THE POST PRESERVE

CASE #00-57Z

DEVELOPMENT TEXT

Memo

PROJECT NAME **POST PRESERVE**
LOCATION **Blendon Gardens**
CITY **DUBLIN** STATE _____

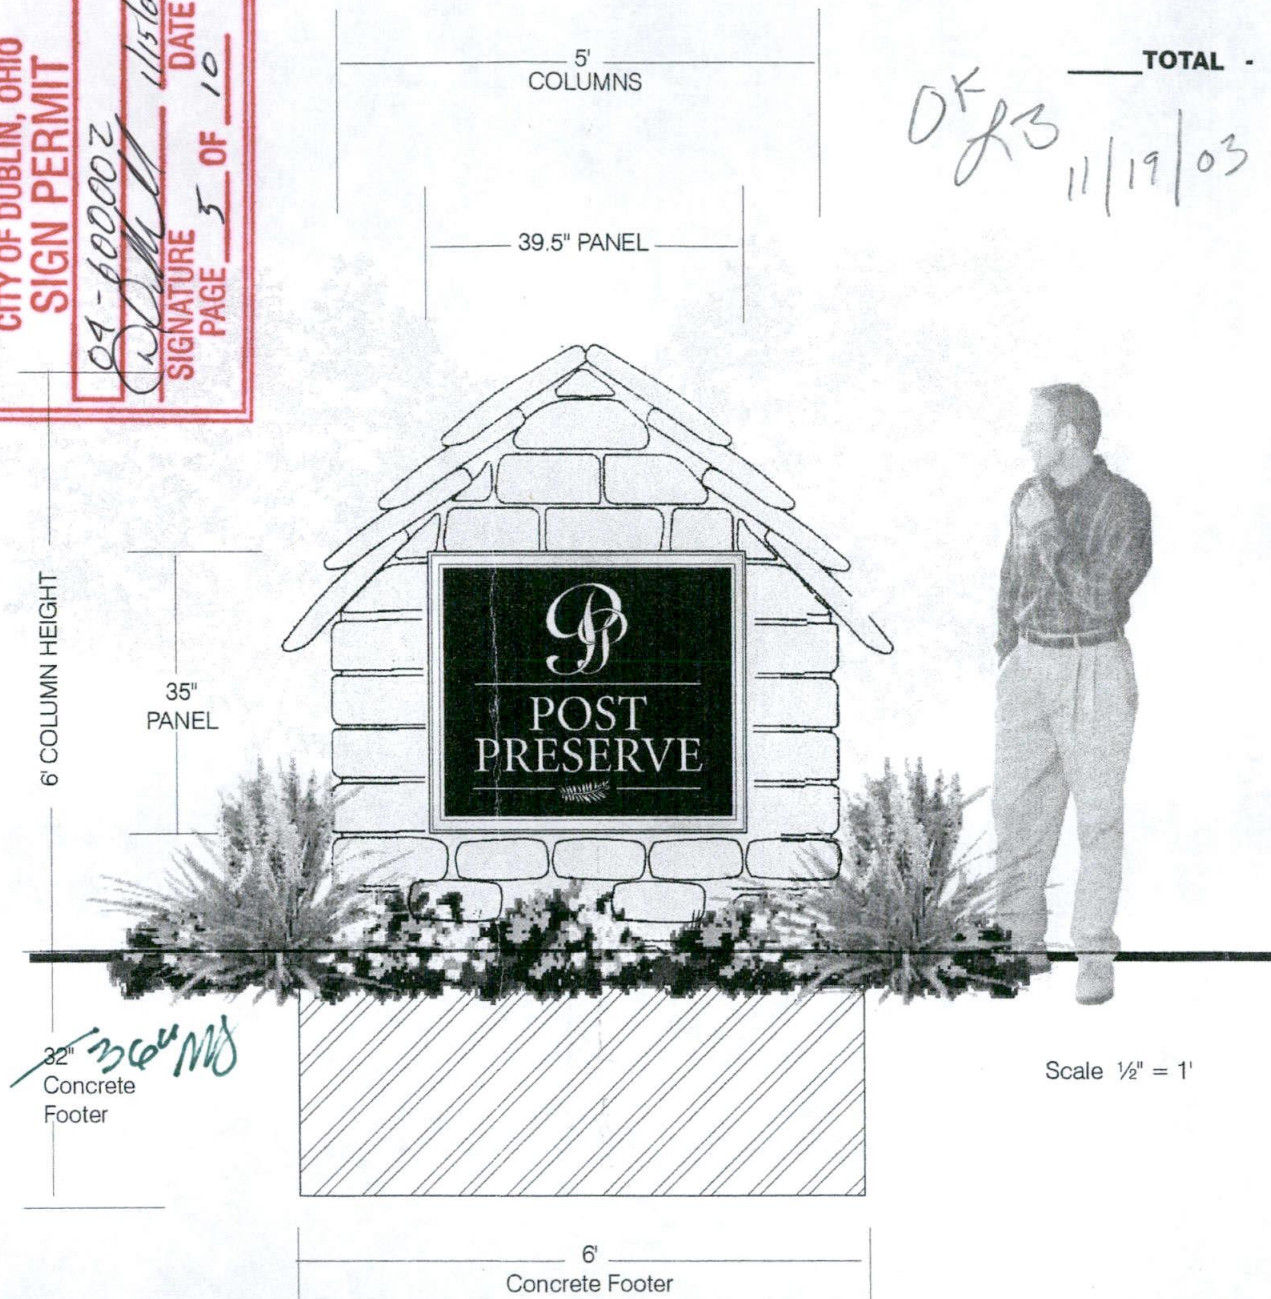
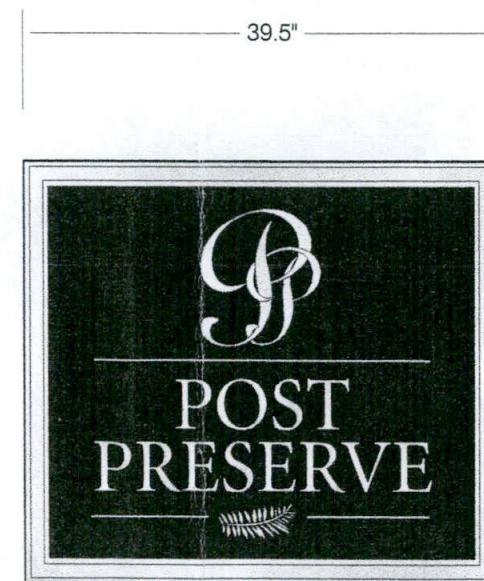
Lloyd T. Simpson from M/I Homes has sent a revised plan for the entrance to Post Preserve. Dominion Homes was the original applicant for this site. M/I Homes then purchased it and minor modifications have been made. Earlier this year staff worked with M/I Homes and their landscape architect on issues concerning the entry feature on the east side of Post Preserve Boulevard. The new plan now includes minor additional landscape elements on the west side of Post Preserve Boulevard. Staff feels that these additional elements are in keeping with the approved plan. The signage has also changed. The original sign package consisted of a hanging sign similar to Gordon Farms. The new sign will be located on a stone pillar. Staff does not have a problem with this either. I believe that these minor changes can be approved administratively and there is no need to return to Planning Commission. Please find the revised plan and attached letter with this memo.

STONE MASON TO USE TEMPLATE PROVIDED TO CREATE RECESSED MOUNTING SPACE FOR PLAQUES. TEMPLATE SIZE = 33" x 49" x 1"

PLAQUES ARE CONCEAL MOUNTED INTO RECESSED AREA IN STONE COLUMNS.

1" THICK FLAT HDU PANEL WITH DIMENSIONAL, DETAILED BORDER.
BACKGROUND IS RECESSED.

"POST PRESERVE" COPY IS RAISED WITH PRISM-CUT TOPS.
ALL OTHER GRAPHICS ARE V-CARVED INTO BACKGROUND SURFACE.
COLORS -
BACKGROUND - BLACK
ALL GRAPHICS - 22 KT. GOLD LEAF
BORDER - 22 KT. GOLD LEAF
